SUBJECT: RIVER BEND STATION, UNIT 1 – STAFF ASSESSMENT OF FLOODING
FOCUSED EVALUATION (CAC NO. MF9899)

STAFF ASSESSMENT BY THE OFFICE OF NUCLEAR REACTOR REGULATION

RIVER BEND STATION, UNIT 1

Figure 3.1-1 River Bend Door Locations (Adapted from Figure 3.1-3 of March 12, 2014, FHRR (ADAMS Accession No. ML14073A647))

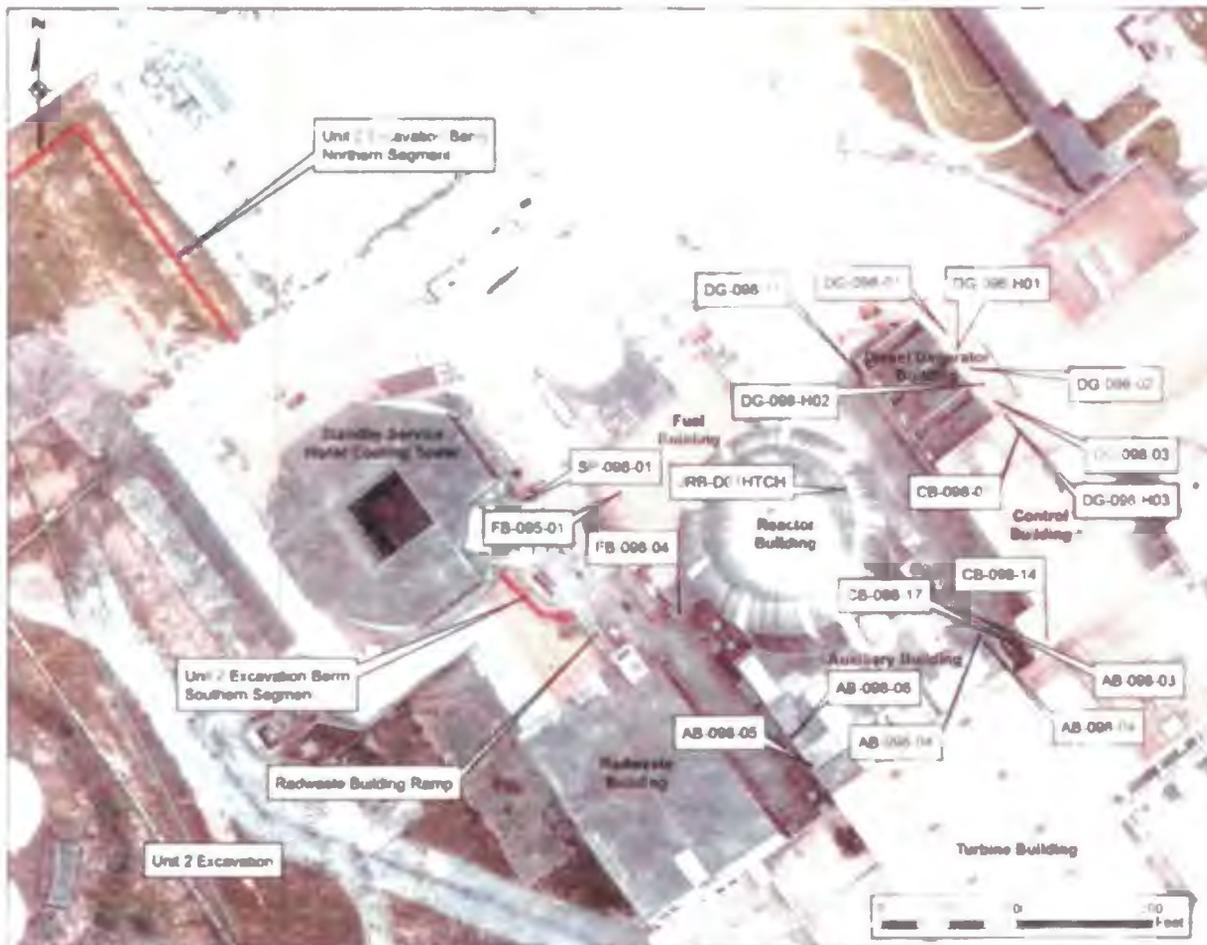
The River Bend FE identified the potential impacts to key SSCs as a result of water ingress due to LIP. The LIP floodwater elevation of 98.3 ft. exceeds the minimum protection elevation of 98 ft. MSL in two areas at the River Bend site, but do not inundate SSCs important to safety. Figure 3.1.1-1 and Figure 3.1.1-2 of this document provide the location of Doors CB-098-17, CB-098-014, AB-098-03, and AB-098-04 that the licensee credits for its conclusion that the LIP event does not inundate SSCs important to safety. These doors are located in the corridor between the control building and auxiliary building where LIP elevations are above 98 ft. MSL.

Figure 3.1.1-2 Critical Door Layout (Adapted from Figure 5.1-2 of March 12, 2014, FHRR)

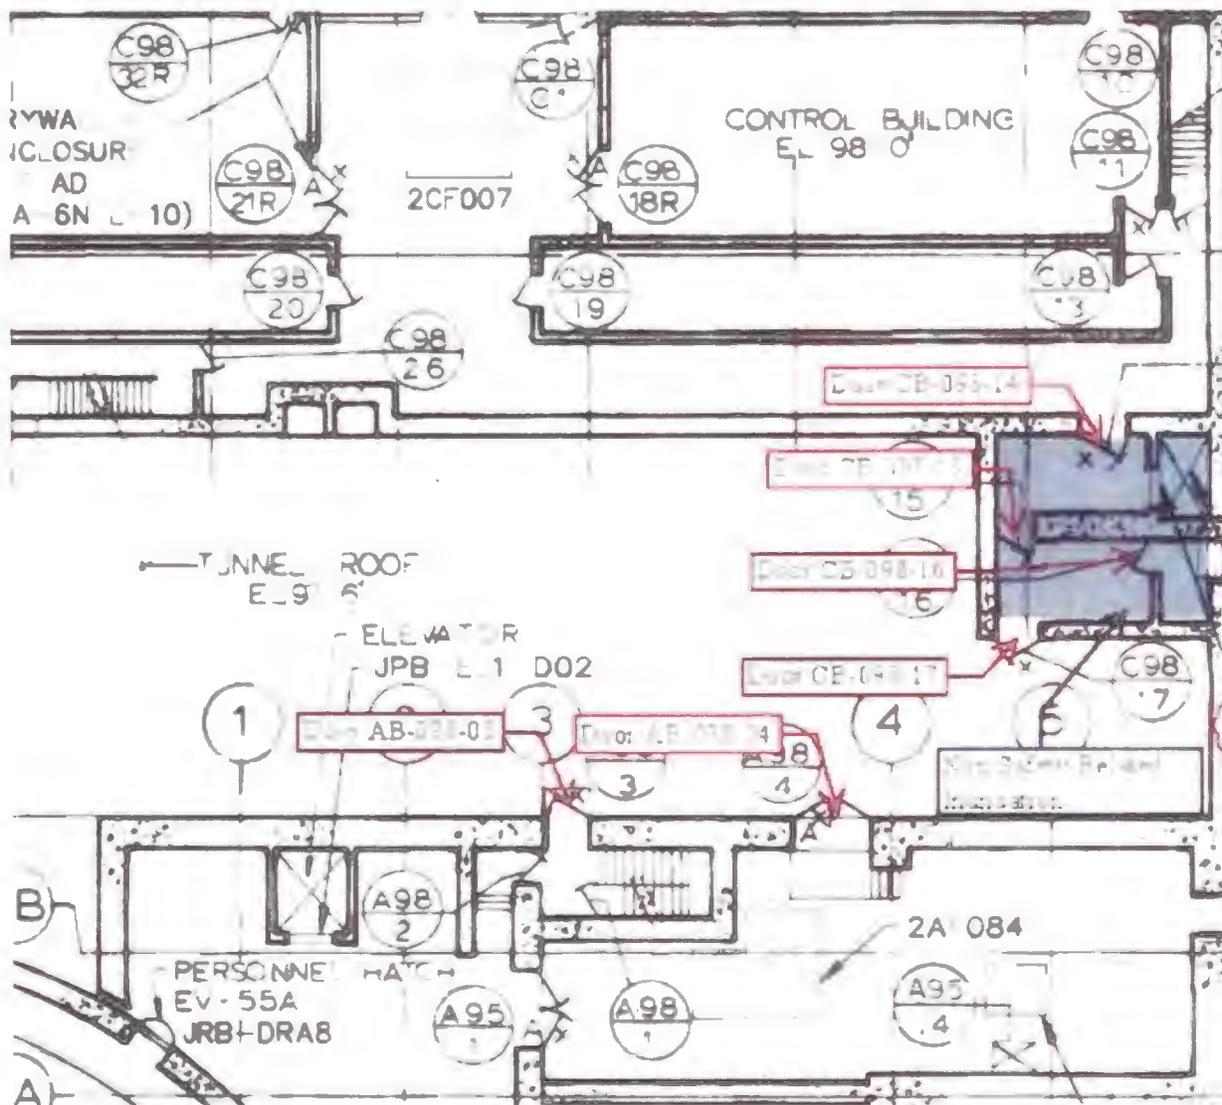
In its FE, the licensee notes that ponding up to 0.3 ft. will occur outside door CB-098-014 after leaking through door CB-098-17. The licensee's FHRR dated March 12, 2014, expands on the discussion of these doors and notes that flood waters penetrating Door CB-098-17 would potentially inundate and penetrate Doors CB-098-016 and CB-098-015. Water penetrating through Door CB-098-16 will enter the bottom of a stairwell, with no impact to SSCs important to safety. Water penetrating Door CB-098-15 will flow into an elevator shaft, with no impact to SSCs important to safety, and would pond against Door CB-098-14, which provides access to SSCs important to safety. The interior area that would be inundated due to leakage through Door CB-098-17 is highlighted in blue in Figure 3.1.1-2.

Based on this door being designed to withstand 28 ft. head of water and experiencing 0.3 ft. head of water due to a LIP event and the procedures the licensee has in place to maintain the leak-tight function of Door CB-098-014, the staff concludes that this door meets the definition of being reliable to maintain key safety functions found in Appendix B of NEI 16-05, Revision 1.
